Enclosed is one copy of the second draft of the Notice of Intention to Revise Large Mining Operations for the Ash Grove Cement Company's Hank Allen Pit (Leamington Plant) M/023/004. This submittal includes a replacement copy of the text of the NOI, and replacement copies of the tables and plates requiring edits as noted in your comments for the first draft (submitted March 5, 2007). In addition, addenda have been provided for Appendix 13 of the NOI. Edits have been made in redline/strikeout format. The revisions made in response to the comments on the first draft have been highlighted. Plates, figures, tables, and appendices submitted as revisions for the first draft that did not require additional changes are not being submitted with this draft.

Application for Mineral Mine Plan Revision or Amendment

Mine Name: File Number: M/023/004

NOTICE OF INTENTION TO REVISE MINING OPERATIONS

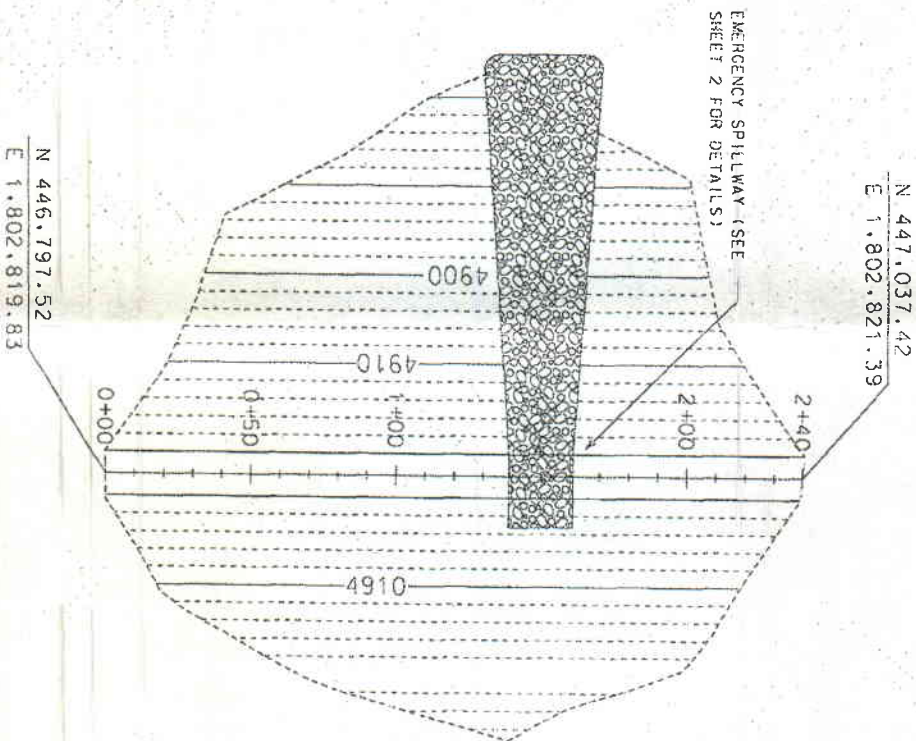
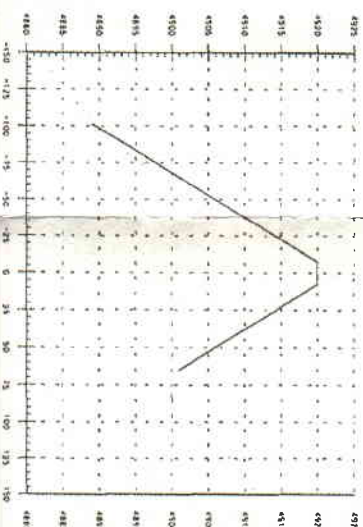
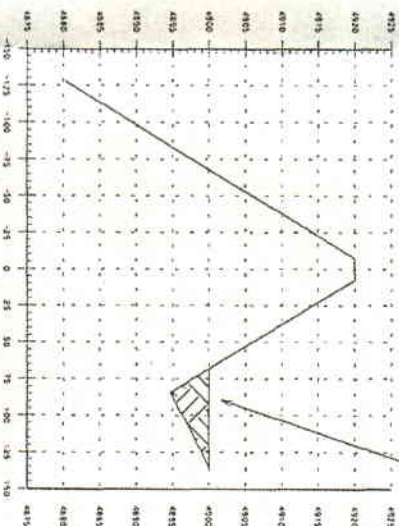
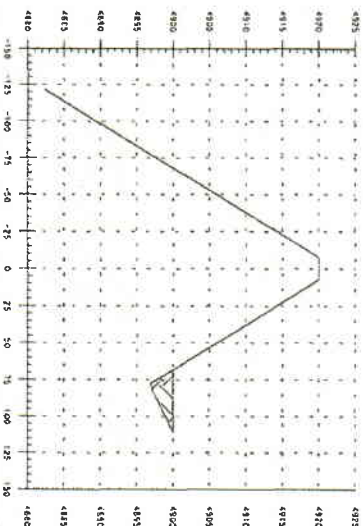
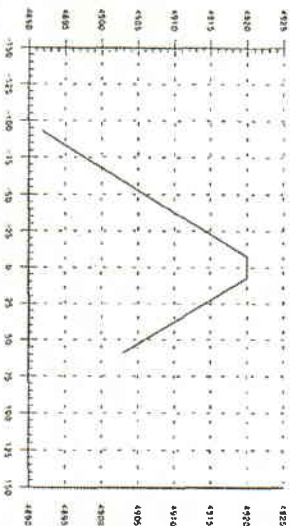
<input type="checkbox"/> ADD	x REPLACE	• REMOVE	Appendix 9. Drawing R647-4-109. Updated acreage of waste rock stockpile.
x ADD	x REPLACE	• REMOVE	Appendix 13. Updated hydrology calculations for the reclamation drainage channels. Added hydrology calculations for Pond 7.
